ALERT SERVICE BULLETIN ASB UH-1H-II-23-XX

MODEL AFFECTED: UH-1H-II

SUBJECT: TENSION ROD ASSEMBLY P/N 205-030-249-009 OR 205-030-249-013, INSPECTION OF.

FIGURE 1. Inspection requirements.

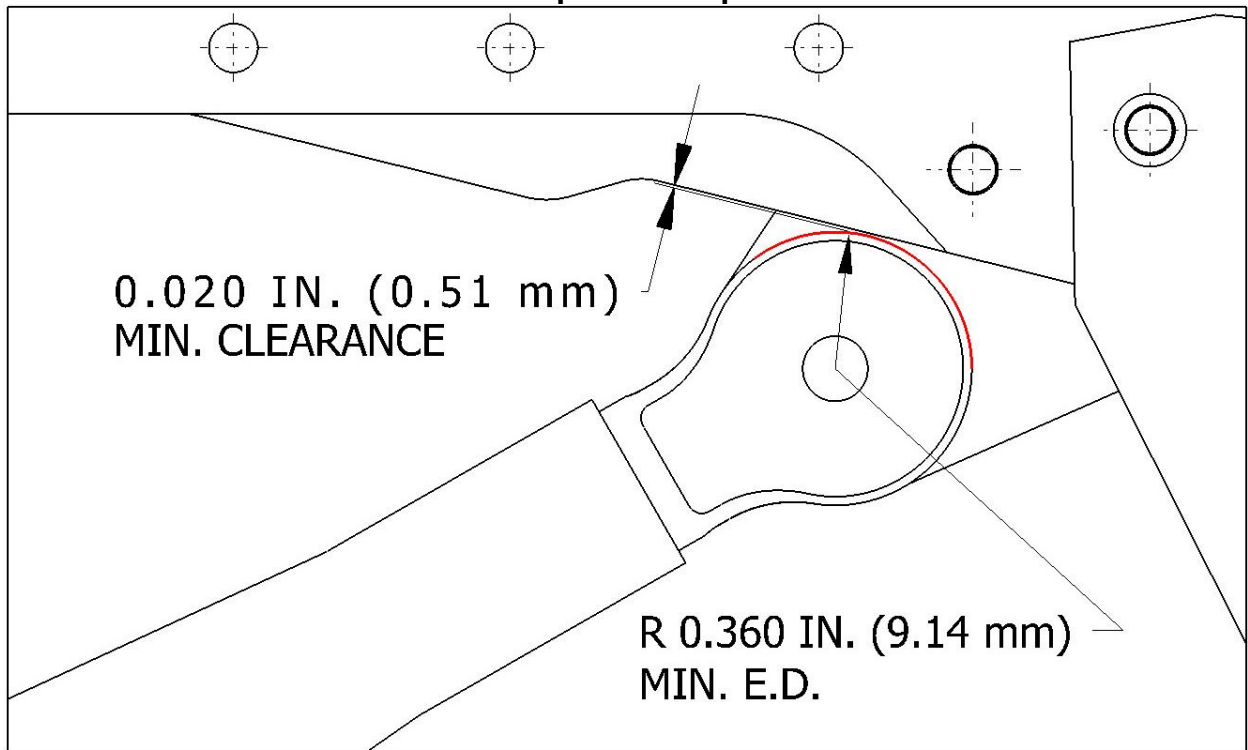
2. Inspect the forward end (upper attachment location) of the tension rod assembly as follows:
 - a. Inspect the outboard side of the tension rod assembly rod end for a possible over trimmed condition. Minimum acceptable radius dimension measured from the bolt

hole center is 0.360-inch (9.14 mm) edge distance (E.D.) (Figure 1). Removal of the attachment bolt may be required to perform this measurement. Record findings. During reinstallation of hardware, if required, tighten the nuts IAW appropriate instructions.

- b. Check for fouling or low clearance conditions between the rod end and the structure (cap, web, angle). Minimum acceptable clearance is 0.020-inch (0.51 mm) (Figure 1). Record findings.

FIGURE 2. Inspection requirements

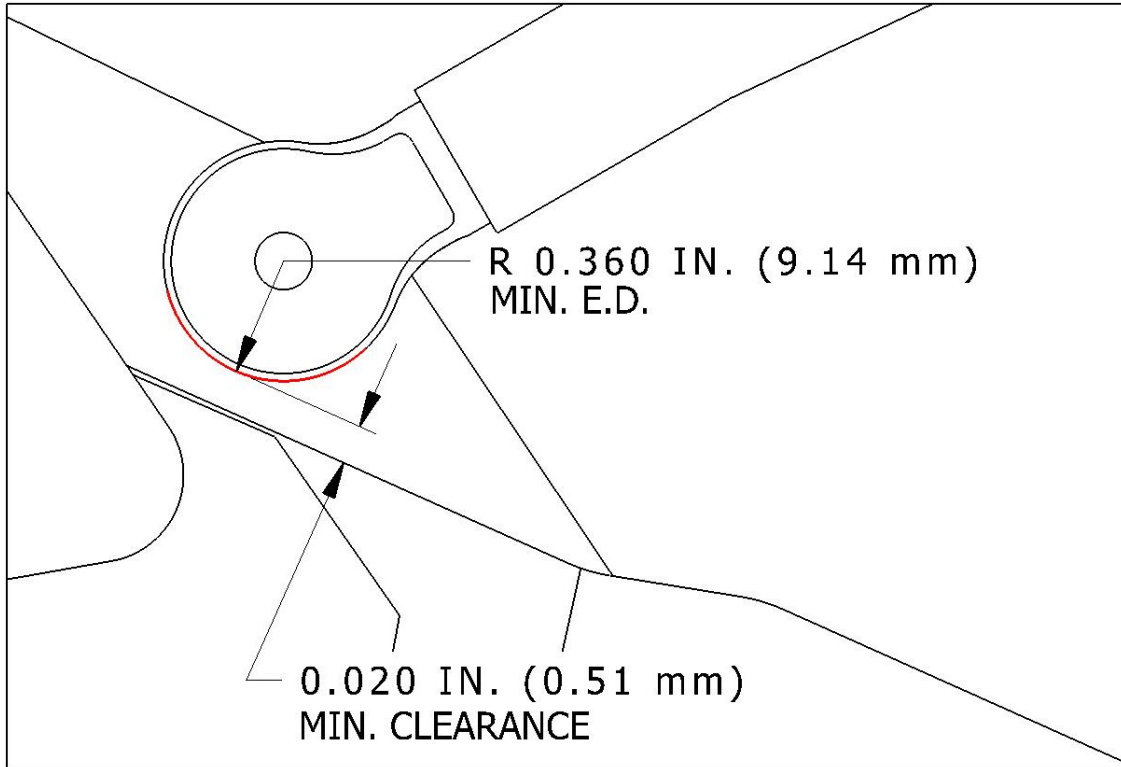
3. Inspect the aft end (lower attachment location) of the tension rod assembly as follows:
 - a. Inspect both sides of the tension rod assembly rod end for a possible over trimmed condition. Minimum acceptable radius dimension measured from the bolt hole center is 0.360-inch (9.14 mm) edge distance (E.D.) (Figure 2 and 3). Removal of the attachment bolt may be required to perform this measurement. Record findings. During reinstallation of hardware, if required, tighten the nuts IAW appropriate instructions.

- b. Check for fouling or low clearance conditions between the rod end and the structure (cap, web) on the outboard side and the fillet radius on the inboard side of the fitting. Minimum acceptable clearance is 0.020-inch (0.51 mm) (Figures 2 and 3). Record findings.

FIGURE 5. Rework requirements
KEEP 0.280 IN. (7.11 mm) MIN. E.D.
FOR FASTENERS (CAP, WEB, ANGLE)

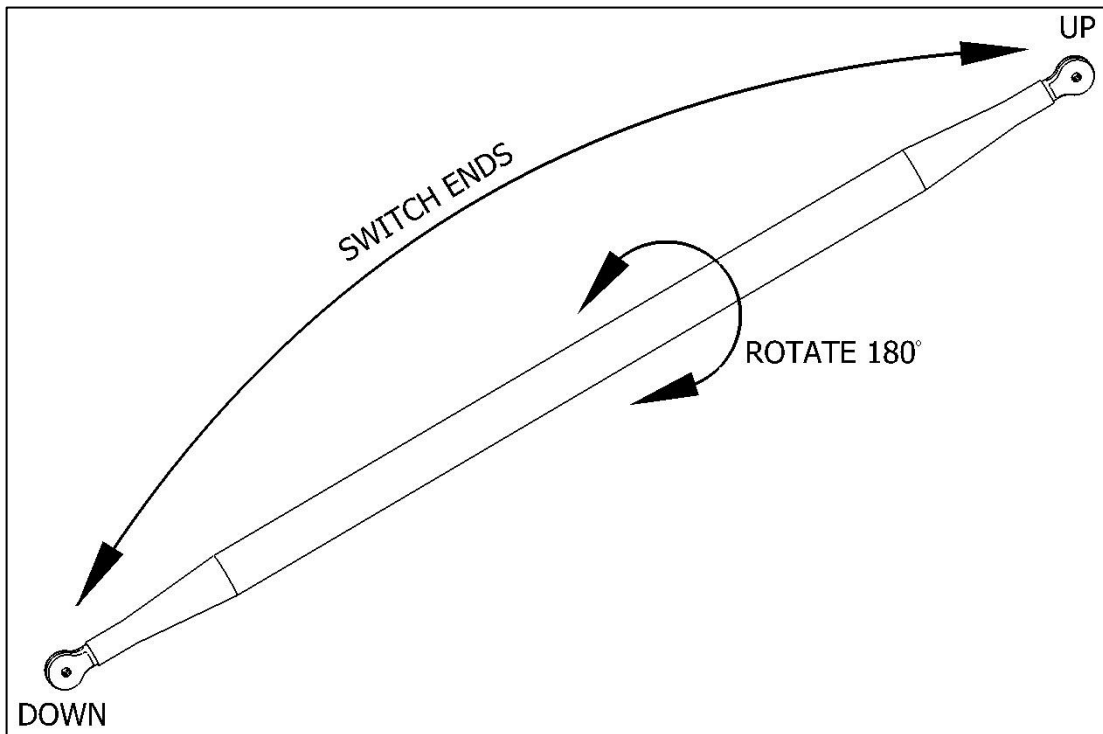
3. Temporarily reinstall tension rod assembly. Mark the minimum material removal required on the affected rod end and/or structure attachment points to obtain the required clearance. (Figure 5 for the upper bolt. Figures 6 and 7 for the lower bolt.)
4. Remove the tension rod assembly (step 1.a.).
5. Trim and deburr previously marked material on the affected rod end and/or structure attachment fitting. Ensure the inspection criteria defined in **PART I** are respected (Figures 1, 2, and 3).
6. Apply chemical film and one coat of epoxy polyamide primer to the reworked area.
7. Install the tension rod assembly (step 2.a.).
8. Make an entry in the helicopter logbook and historical service records indicating compliance with this Alert Service Bulletin.
